Docket Item # 2 BAR CASE # 2016-0114

ISSUE:	Park improvements
APPLICANT:	City of Alexandria Department of Project Implementation
LOCATION:	421, 500, 500A, abutting parcel south of 500A, 501, 520 & 600 S Union St (Windmill Hill Park)
ZONE:	WPR / Waterfront park and recreation

## BAR2016-00114

### **Pedestrian Pier**

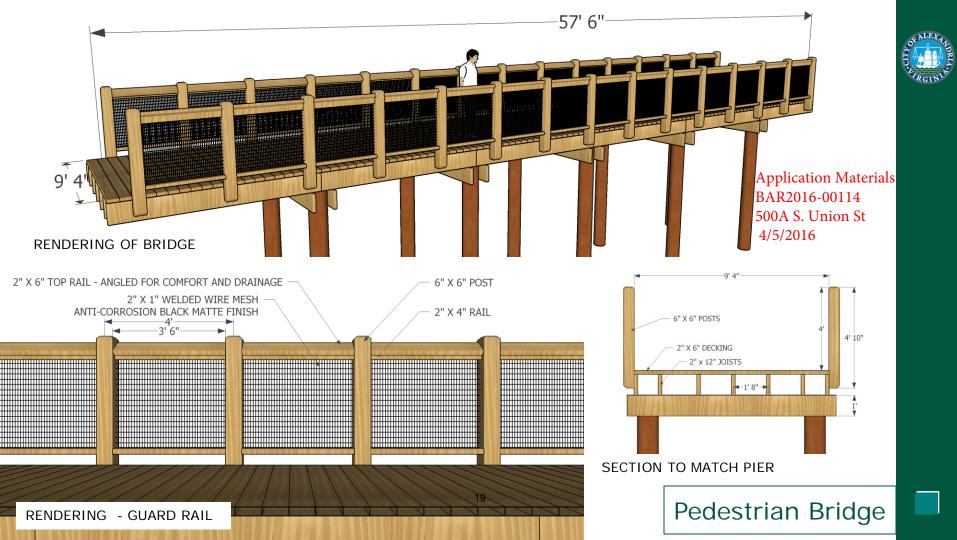
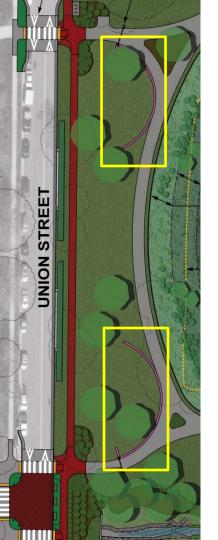
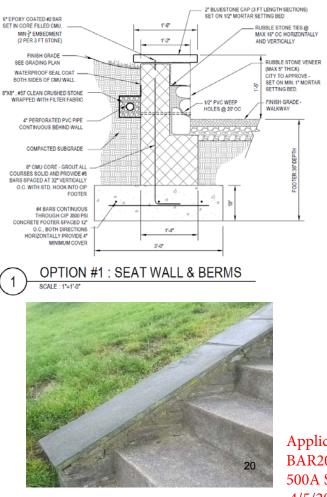
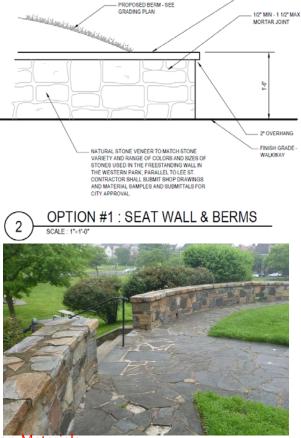
- 1. The metal mesh portion of the railings should have a matte finish.
- 2. Lighting consistent with the Waterfront Common Elements for the promenade area shall be used where replacement lighting is proposed adjacent to the path, once the Common Elements are approved.
- 3. Historic interpretation consistent with the Waterfront Common Elements should be included at this site in the future, particularly interpretation related to rail transportation and industrial heritage.

While there are no specific *Guidelines* for these particular elements, the general tenets of the *Guidelines* suggest that the proposed materials should be durable, high-quality natural materials found throughout the historic districts. Further, these elements should complement the historic character of this area rather than ostentatiously announce their presence. Previously, the BAR expressed concern about the use of concrete decking and use of an industrial character bridge, seemingly because it was found in a park in another part of the City. The BAR encouraged the use of a natural material like wood and a simple railing, consistent with other waterfront pedestrian piers. For the required railings, staff also recommends that the metal mesh have a matte, not shiny, finish.

Site Lighting – Gadsby Pole Replacement Interim light pending W.F. Common Elements light selection.

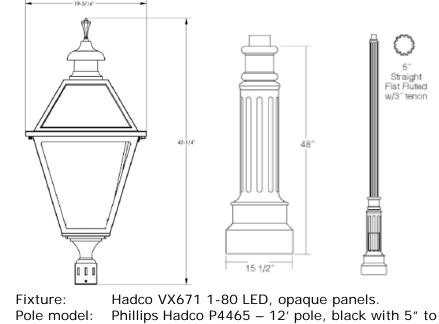
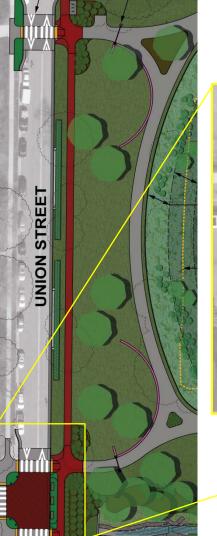
The programmatic requirements of the project scope require replacing existing streetlights on the northern path and installing limited new streetlights where there are seating areas for safety purposes. Staff finds this lighting scheme to be a modest level of illumination that will continue the natural feel of this particular park while providing appropriate lighting for overall safety. It should be noted that the specification of Gadsby streetlights in the park is an interim proposal until the Waterfront Common Elements palette is approved. Concurrently, the City is in the process of selecting an appropriate Gadsby Replacement Streetlight that will be more historically

accurate, much more energy efficient, and substantially less cost to replace. As part of the Gadsby Replacement Streetlight project and the Waterfront Common Elements, there has been discussion and general consensus that the Gadsby Streetlights should be true streetlights and used only on streets. While the existing Gadsby Streetlights are found all over Old Town, and in some curious locations, it is quite likely that the intention going forward will be to be more conscientious in determining where they are installed. It is expected that the BAR will review the Waterfront Common Elements palette and Replacement Gadsby Streetlight for separate Certificates of Appropriateness on July 20, 2016.

The Waterfront Common Elements will include a unique promenade light that will be used to visually link the public path along the entire length of the waterfront. In the future, as each waterfront park is fully designed, there may be additional lighting options for other areas in the interior of the parks, street-end gardens and piers. Because the Gadsby Streetlights are by function and aesthetics a more traditional streetlight, staff recommends that an alternate light, consistent with the Waterfront Common Elements palette be used in Windmill Hill Park. The use of lights from the Common Elements for the pathway and seating area will also knit this particular park into the overall waterfront park program and further connections along the waterfront. Staff recommends that once the Common Elements are approved, the selected promenade light should be used in the limited lighting areas in Windmill Hill Park, adjacent to the path, as the character of this area is more similar to the park promenade than the street. Should the final promenade light not be selected in time for the construction at Windmill Hill Park, the replacement Gadsby Streetlight may be installed only as an interim condition.

C-1 Page 3 indicates pole lights to be located along the north path and along seating areas. Applicant must show the location of all proposed lights on the plan and in compliance with the 12' setbacks.
